Request for Information

TO	Robin Berry – Donna Horn
JOB NAME	CP0096 Mesa Burn Facility Expansion
DELIVERY	FTP Site Upload
RFI #	14REV -1
FROM	JE Bowen Construction
DATE	06-21-2016

Request: Plan page S-3 columns lines C-5 D-5 D-6

3
S5 **ALTERNATE BEAM TO COLUMN CONN.**
(REVISED DETAIL)

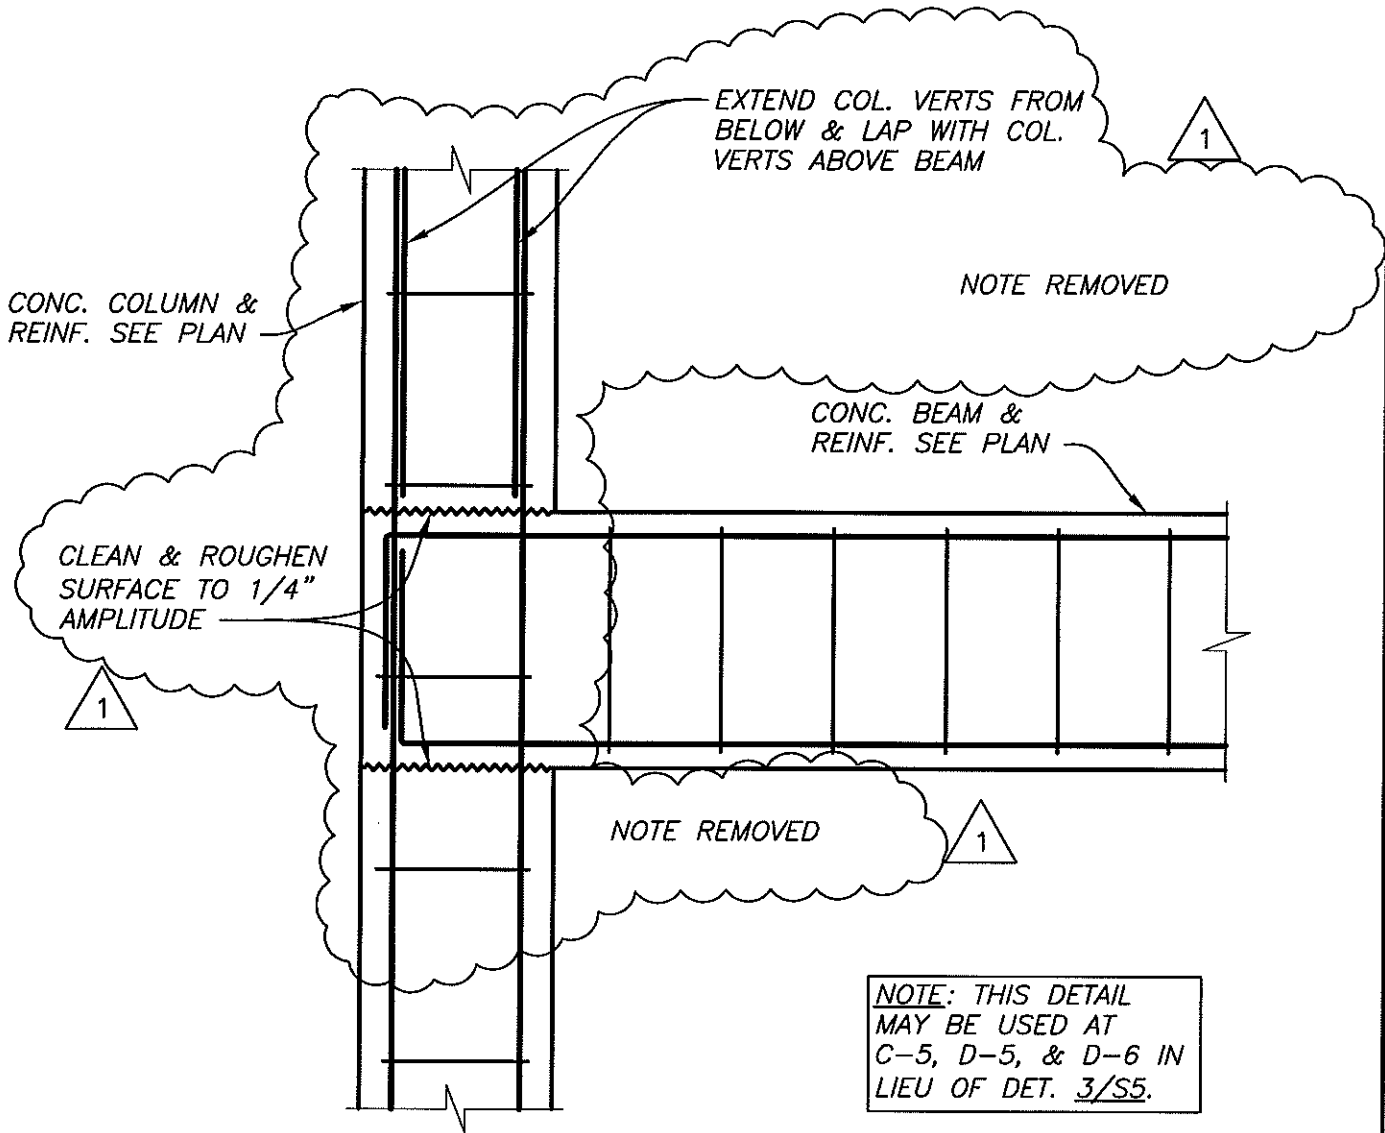
Please provide beam to columns details at these three locations where the beam and columns intersect.

REVISED We are requesting that you revise this detail to confirm with how we are going to pour the concrete?
See attached notes

SEE SHEET SS-4 WITH DELTA 1 REVISION
DATED 6/23/2016.

NOTE: THIS DETAIL
 MAY BE USED AT
 C-5, D-5, & D-6 IN
 LIEU OF DET. 3/S5.

CONTRACTOR ALTERNATE FOR 2ND FLOOR BEAM TO COLUMN
 CONNECTIONS AT C-5, D-5, & D-6. (REVISED FOR 3 POURS)
